# Critique

## by the Committee to Bridge the Gap

## Navy's Draft Fifth Five-Year Review

## Hunters Point Naval Shipyard

#### strontium-90 Radiological Retesting for Soil HPNS Parcel G

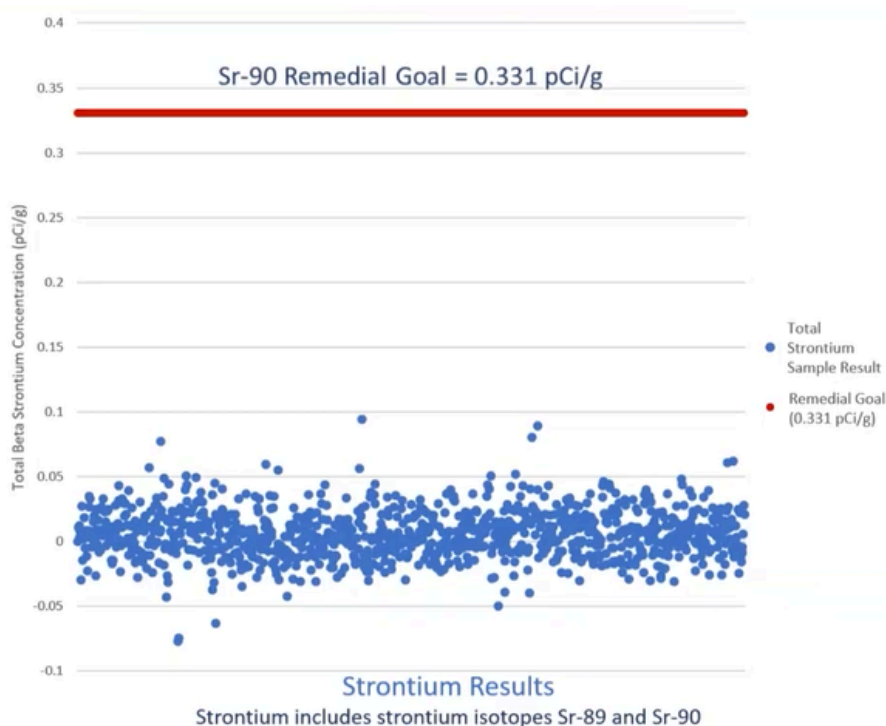
EPA objections – by claiming its own testing method was faulty. At the October 25, 2021 Community Advisory Committee (CAC) meeting, the Navy “presented” the Sr-90 data (see chart to the left); instead of displaying the exceedances, though, the Navy left them out altogether.<sup>34</sup> The decision to withhold the exceedances and keep them off the chart was the first instance of the Navy hiding information on the Sr-90 issue from the public – but it wouldn’t be the last. And it is strikingly parallel to the original allegations of data manipulation and elevated readings being thrown out that triggered the need for retesting in the first place.

After finding nearly two dozen soil samples with Sr-90 above the remediation goal (RG), the Navy proceeded to throw out its own elevated readings. The Navy then attempted to change the testing method. Although publicly claiming that it was only tweaking small parts of the original method and was still using EPA Method 905.0, the Navy’s real change was to the separation technique itself from that required in EPA Method 905.0. EPA accepted the switch to a new method, but continued to tell the Navy that the original exceedances were valid data and that the Navy should not claim otherwise.
